NEW FEATURES

■SEAT

04Z1HA16Y

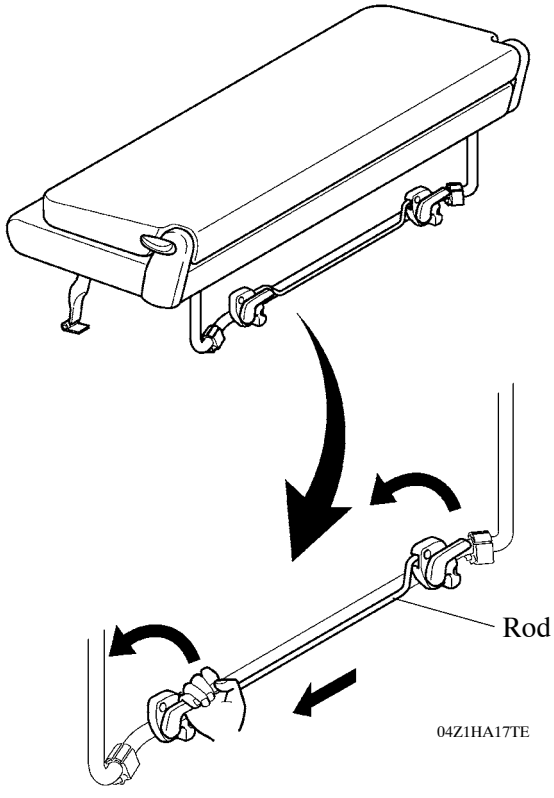
A 13 (3+3+3+4) seat layout is available on the standard wheelbase GL grade model for some general countries (Mexico and Venezuela).

04Z1HA17TE

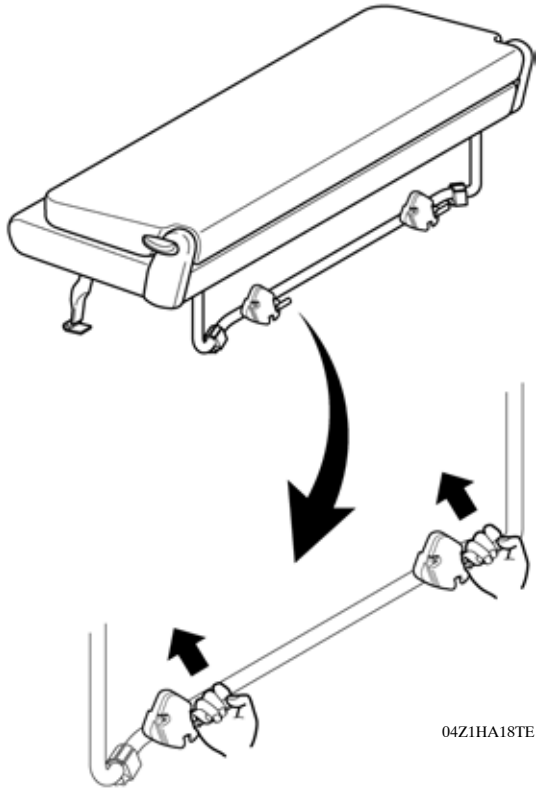
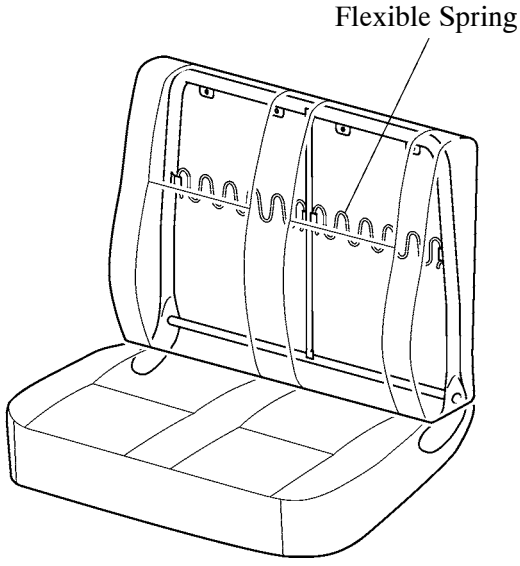
- On van models, the rear seat lock can be released by independently operating the left and right levers in a conventional manner. However, on new models, the levers are coupled through the rod, thereby allowing the rear seat lock to be released by operating either lever.

04Z1HA19TE

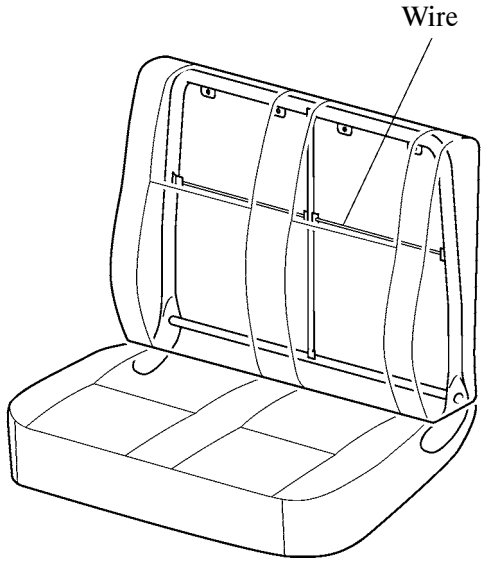
- The hard wire previously used for retaining the rear seat pad has been replaced with a flexible spring one in order to absorb any impact energy applied to the knees of an occupant seated in the rear seat when the rear seat pad comes into contact with them, thus protecting the knees of the occupant.
